Fingerprint Terminal V1.4.0_build230403

Release Note (2023-06-14)

Fingerprint Terminal V1.4.0_build220523

Release Note (2022-05-25)

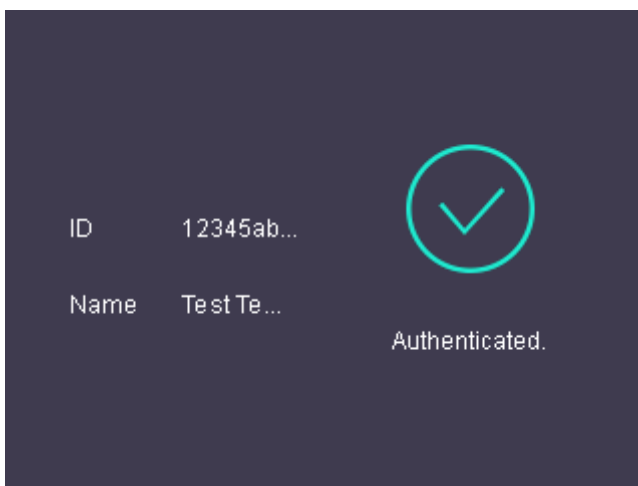
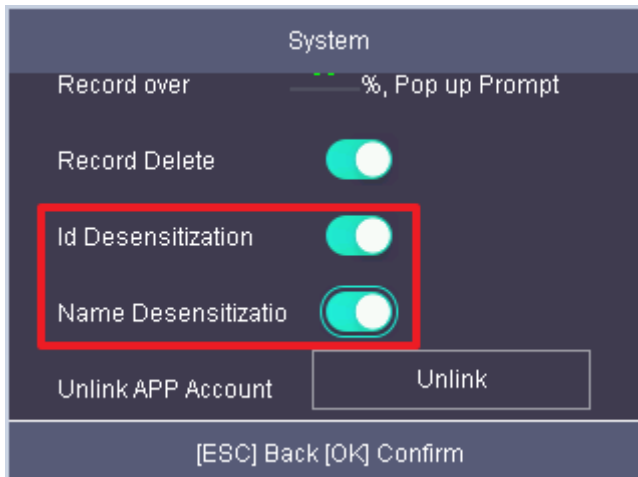
1. ID support letter, ID length less than 32 digit

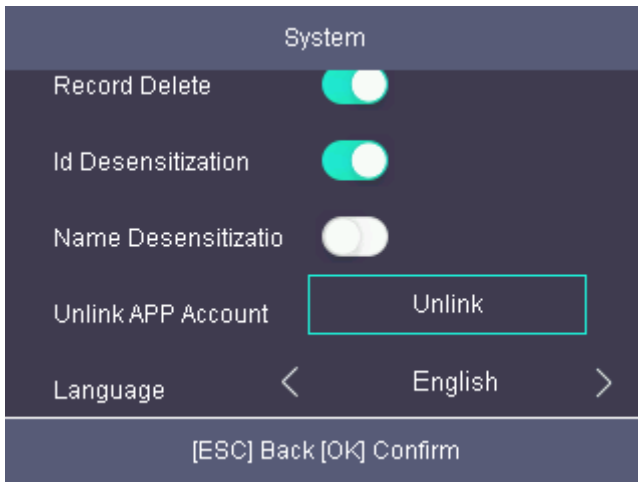
2. Support ID, name desensitization function

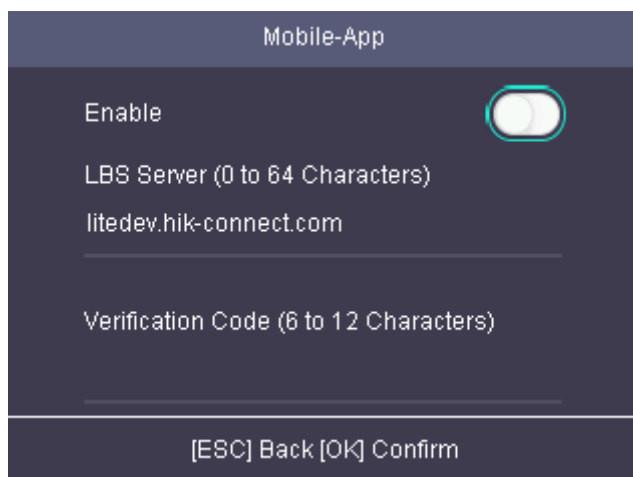
4. Add Hik-Connect menu in device UI Menu→Comm→Mobile App. The function is disabled in default. (For DS-K1T804A, DS-K1T804B, DS-K1T8003 only)
